Proposal Request 32 Rev 1

Project: LFUCG Phase 1B

Subject: Door type change for door 132

Proposal Request 36

SHEET NUMBER: **C1.1**

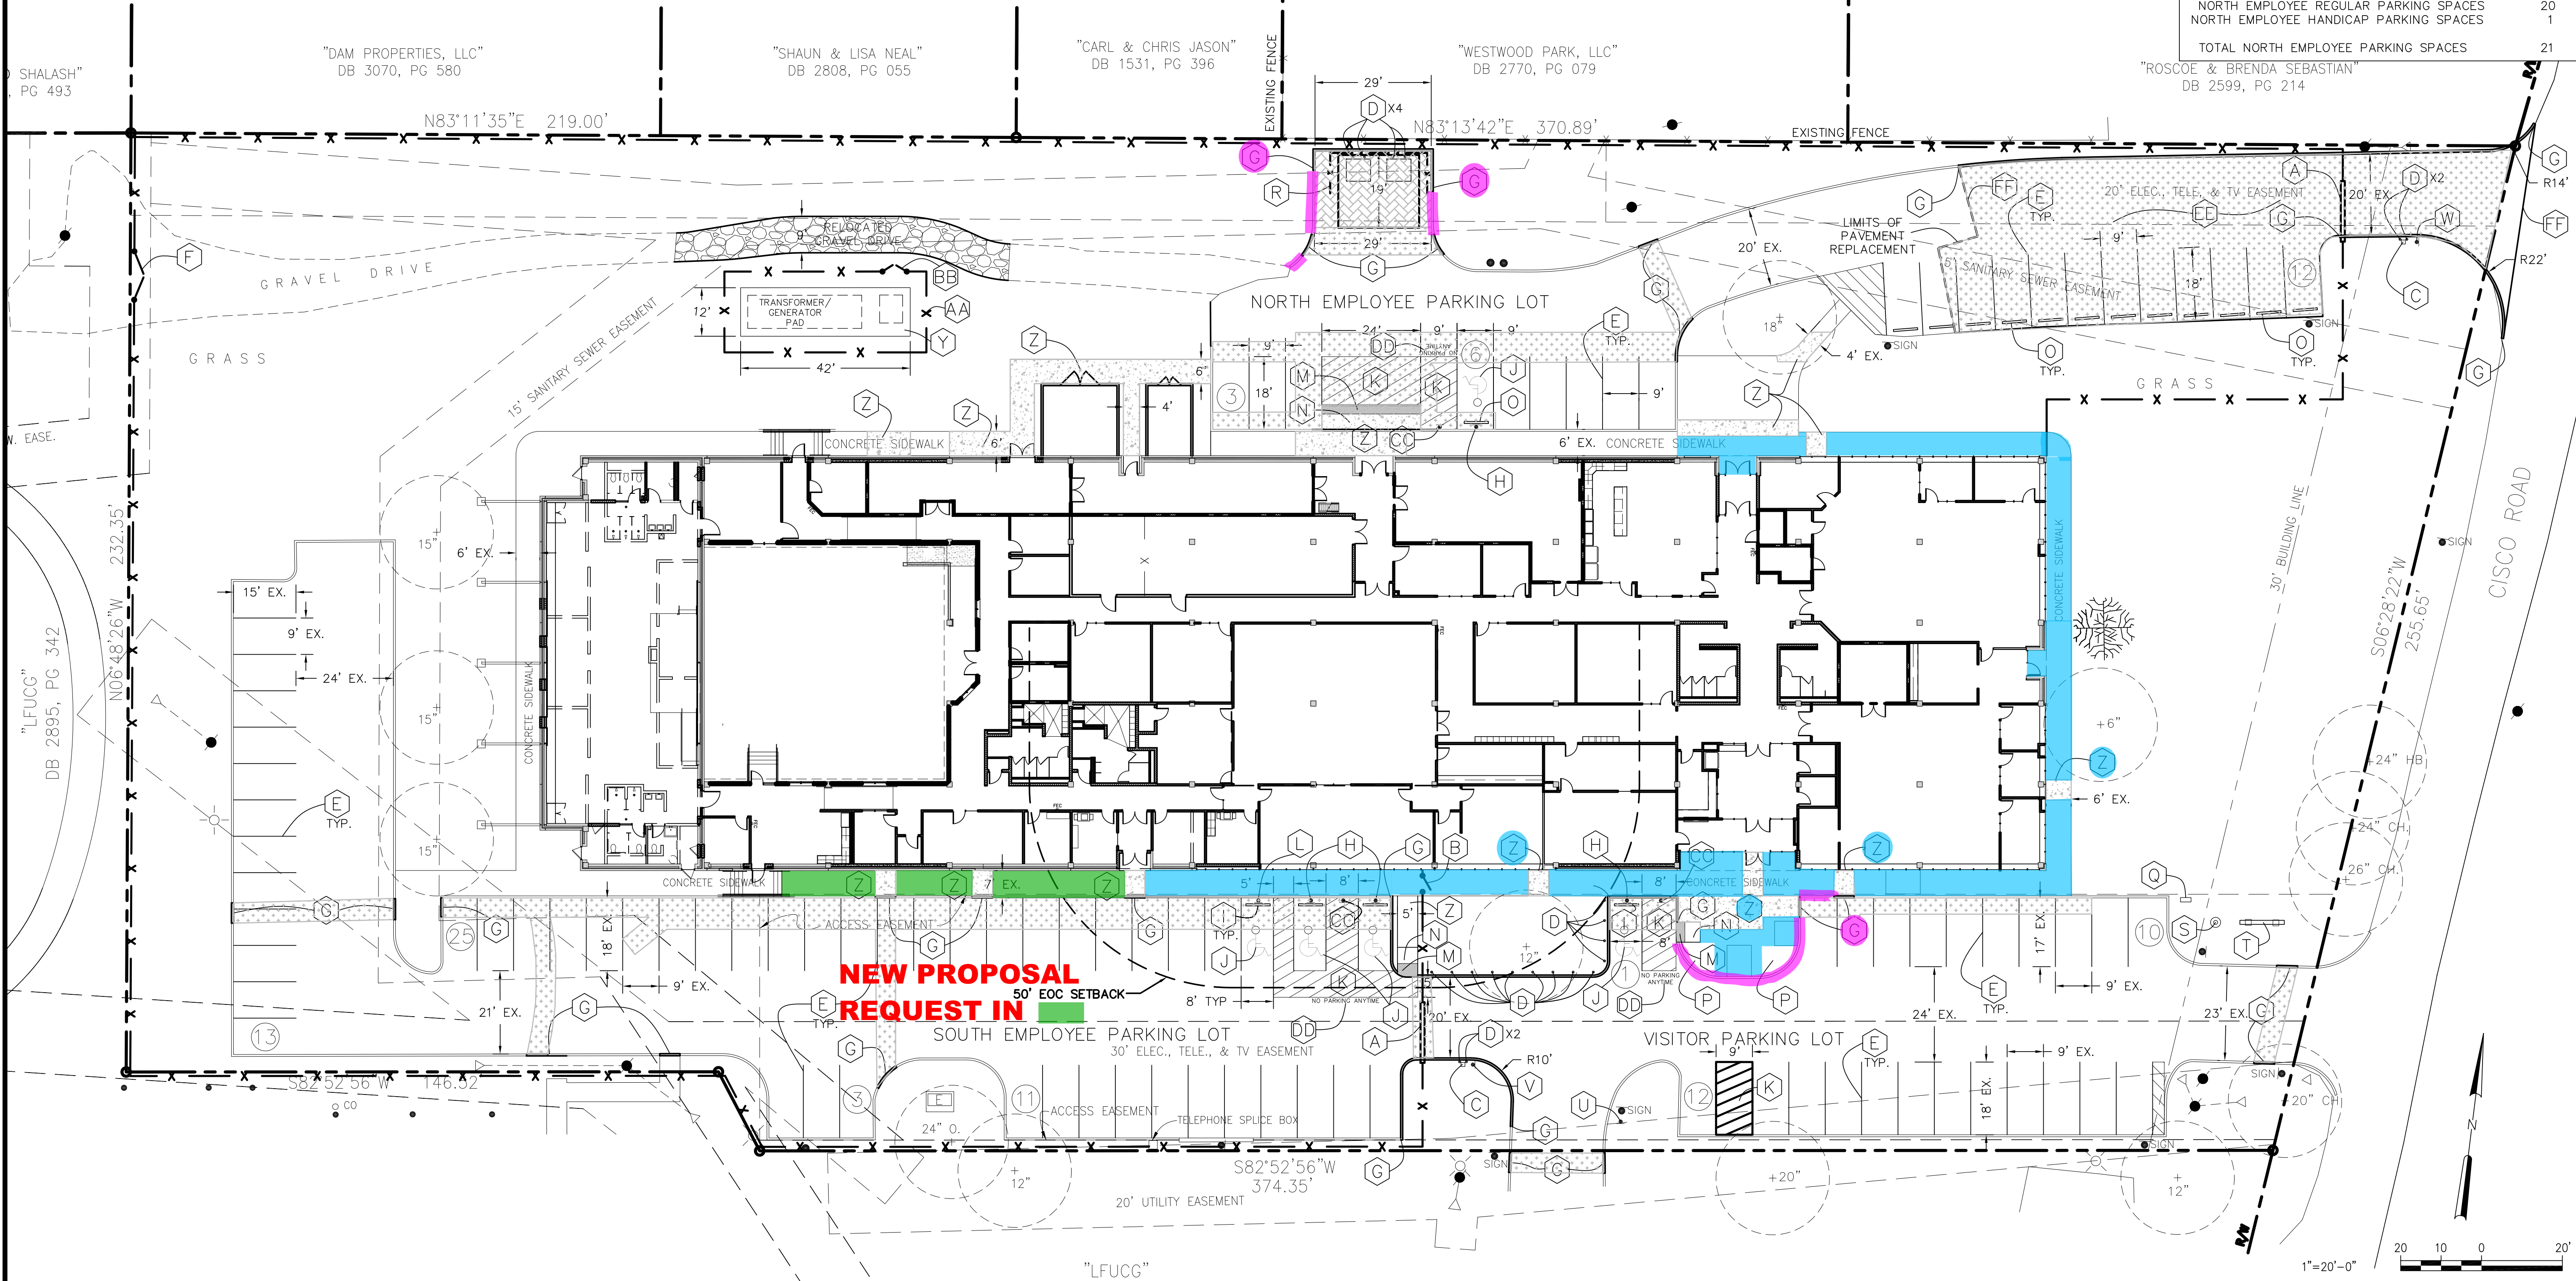
Subject: Additional Sidewalk

See attached changes from Owner regarding sidewalk area highlighted in green. Unit pricing applies.

Project: Public Safety Operations Center	Date: 11/11/15
Project Number: MGT 1316	
You are authorizing us to perform the following additional work:	
Form and pour an additional 77 linear feet of concrete @ \$99.04/lf	\$7,626.08
Install an additional 77 lf of sidewalk caulking @ \$5.77/lf	\$444.29
TOTAL ADDITIONS	
	\$8,070.37
15% profit and overhead	\$1,210.56
Please Note: The attached drawings show 85 LF of additional sidewalk. 8' of the 85 Lf was done as part of the original scope of work per contract. Unit pricing is per PR #11 Rev. as discussed with LFUCG.	
TOTLA AMOUNT OF CHANGE ORDER:	\$9,280.93
We hereby authorize the above change order to be completed Additional work is to be performed under the same conditions as specified in the original contract unless stipulated otherwise.	
Date: _____	Owners Signature: _____
Churchill McGee LLC	
Date: _____	Authorized Signature: _____
